**From:** Bruce Titus <brucet@brucetitus.com>  
**Sent:** Thursday, January 10, 2019 4:22 PM  
**To:** Cari Hornbein; Paula Smith; Tim Smith; Nathaniel Jones  
**Cc:** Daniel Rehberger; Tom Skillings  
**Subject:** Wellington Heights  
**Attachments:** Bruce Titus Drainage Analysis PDF.PDF

**Drainage Evaluation**  
**for**  
**Bruce Titus, Chrysler Jeep**

Skillings Connolly has been retained by Mr. Bruce Titus to evaluate the drainage report prepared for the proposed Wellington Heights subdivision. I have reviewed the drainage report prepared by Olympic Engineering, dated March 29, 2018 and the soils reports prepared by Bill Parnell, PE and MTC. I have also reviewed the amendment letter to the Drainage Report prepared by Olympic Engineering, dated December 4, 2018. I offer the following observations and comments:

**Historical photo, dated June 1990**

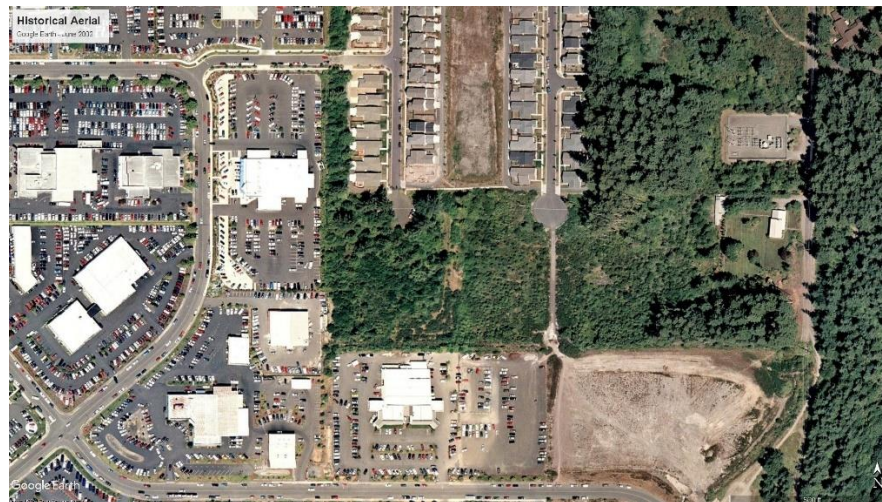
It can be seen from the photos above, there was minimal development to the north of the Titus property in 1990. As developments were constructed, overflow drainage was directed to the toe of slope ditch on the Titus property. It was never designed for 44 cfs.

## Mound Exhibit with potential higher water table

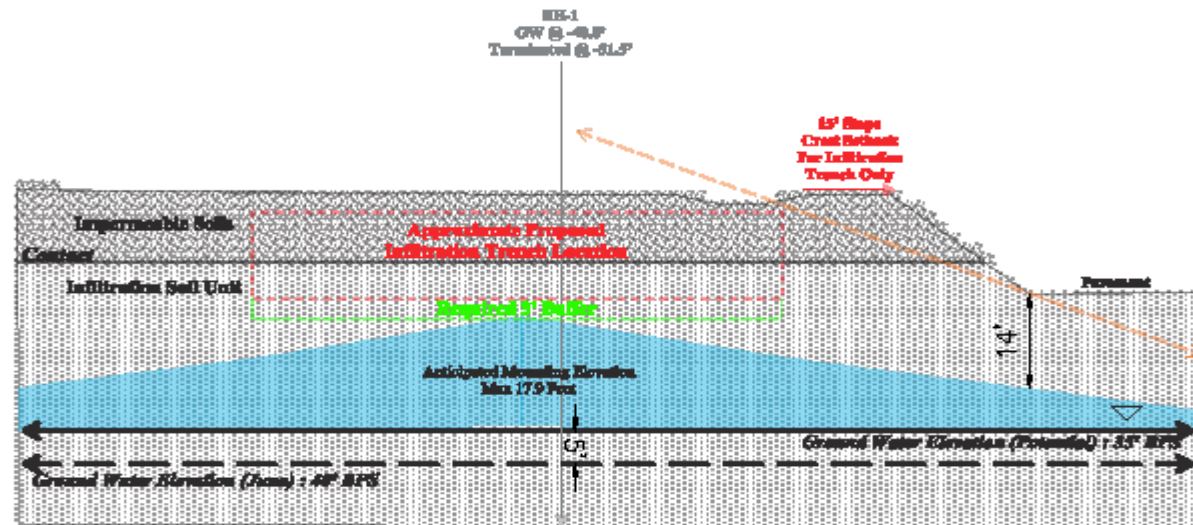
I reviewed the soil borings and mounding analysis prepared by MTC. The proposed project infiltration basin is located in the vicinity of BH1 and TP2. The Bore hole was advanced to a depth of 51.5-feet on June 21<sup>st</sup>, 2018 and the water table was found at a depth of 40-feet below ground level. The mounding analysis estimate performed by MTC indicates the anticipated mound that will develop under the infiltration pond will be 17.9-feet. MTC indicates this will place the mound 9-feet below the bottom of the infiltration pond. This is well below the required 3-foot separation between the pond bottom and the groundwater mound surface. The spring and summer of 2018 had less than normal rain fall. There is no mention of where the groundwater would be in the winter or early spring after a wet season. I did not see any winter evaluation of water levels. If the winter water level were to rise over 5 feet, the mound surface would penetrate the required 3-foot buffer. It is not unreasonable a water tables to fluctuate 10-20-feet or more, during extreme weather cycles. If the water level rose 10-feet, the mound would intercept the bottom of the pond, and the mounding analysis assumptions would no longer be valid; the infiltration pond would fail. The predicted mound surface geometry may look significantly different than the mound predicted in the Olympic Engineering report and. (see attached exhibits)

This issue is the most concerning to me. The developer's design of the 100% infiltration for the stormwater generated from the site is based solely on one summer measurement of the groundwater. If the groundwater rises 5-feet from what was recorded, it does not meet standards. If the water table rises 8-feet above what was recorded, the system will begin to fail. It is critical the winter water table elevation be understood. Typically we would see at a minimum, a one-year analysis of the water table. In addition, because this design feature is so important, the design of the emergency overflow to prevent uncontrolled overflow, or uncontrolled lateral flow that would surface on the north slope of the Titus property. Should be design to provide 100% assurance it will not have an uncontrolled failure.

\*Mounding analysis shown published by MTC  
See attached MTC "SLOPE PROFILES"

- **The Developer should be required to conduct a thorough analysis of the seasonal water table variation found in the Qvr aquifer at this site. I would recommend approval of the proposed design be withheld until the winter water surface level below the proposed drainage facility is completely understood and quantified. If the water level in the aquifer is much higher in the winter than in the summer as measured, the likelihood of failure of the infiltration system is high, and the potential impacts resulting from a failed infiltration basin can be difficult to remedy.**

Topographic Map Exhibit

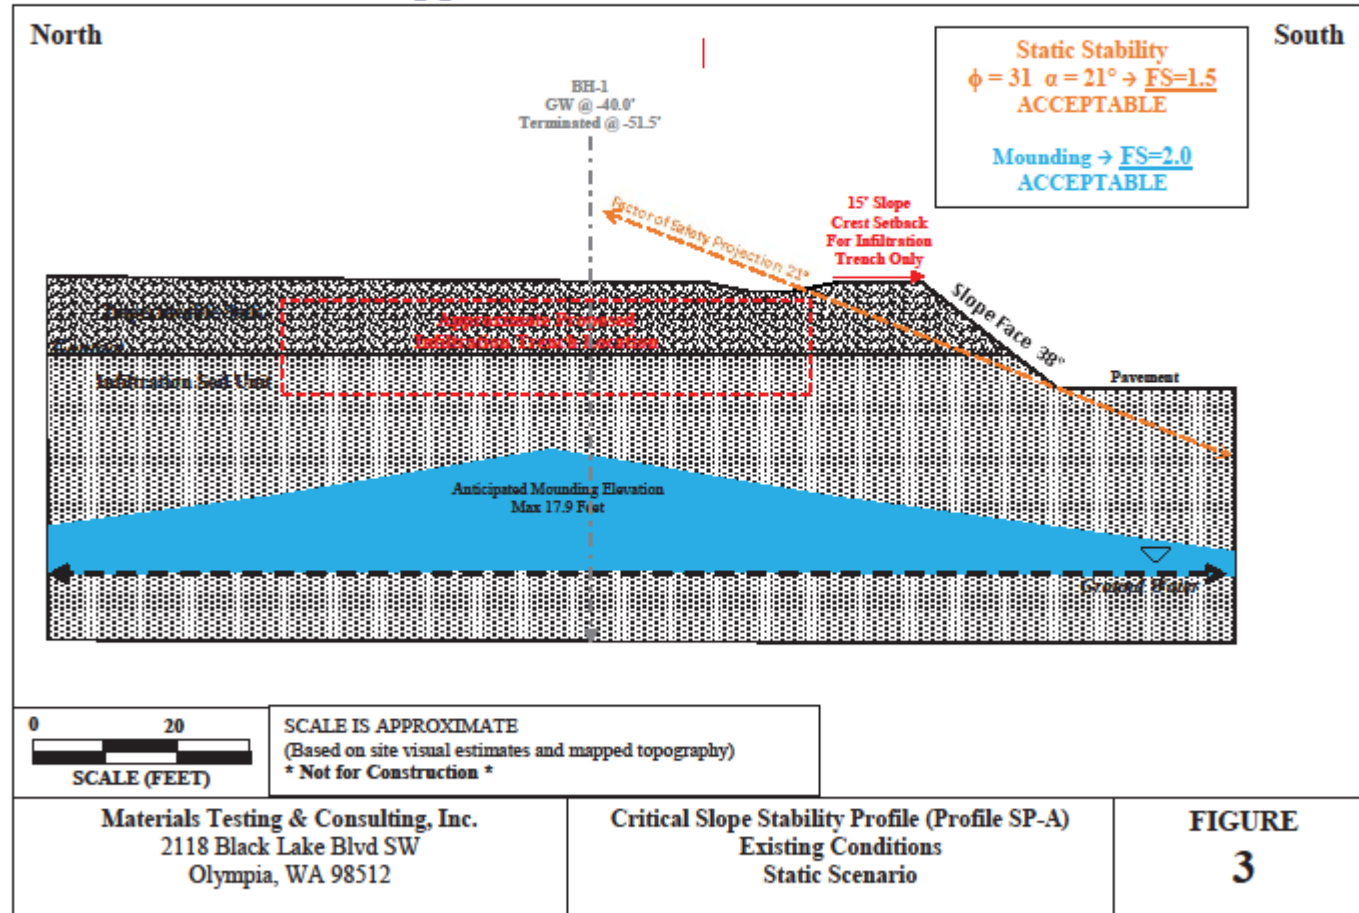
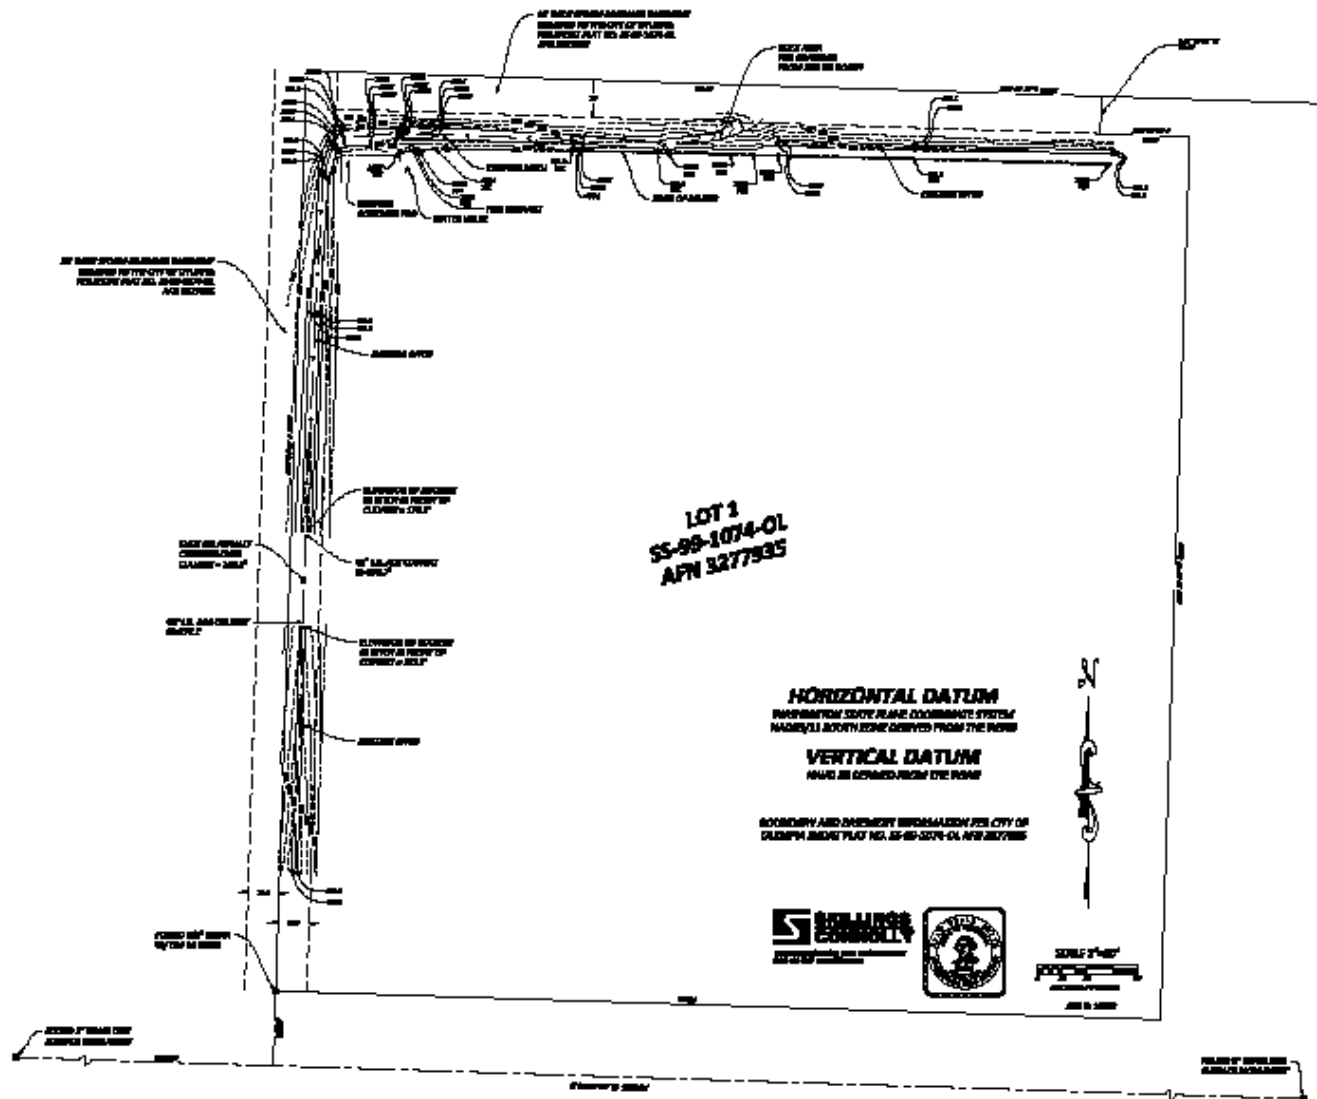
The above referenced documents indicate the ditch along the bottom of the slope was not built per the original Anderson and Boone design, dated February 2, 1987. I have attached a copy of the ditch sections enlarged from the original plan sheet. I have also had my crew survey the ditches. A copy of the topography map of the subject area is included as an exhibit. I don't find any significant variation from the 1987 plans from what exist today, with the exception of the fill that was placed in the Dealership's ditch. This fill was apparently placed when the overflow ditch from the developments to the north of the Wellington Heights project was installed. The riprap and fill totally fill the existing ditch. The ditch section upstream and downstream of the fill is fairly consistent. I would disagree with Olympic Engineering assessment that the ditch was not constructed per the original plan. (see attached ditch sections) The ditch bottom varies in width of 2-4 feet; the back slope varies from 1.5:1 – 2:1 and the front slope varies from 1:1 – 2:1. This variation is pretty normal for a ditch that was constructed over 30-years ago.

the EW ditch has been impacted by the construction of the flow-through drainage ditch. Please see attached exhibits, including historical photos, survey topo map, and historical pictures.
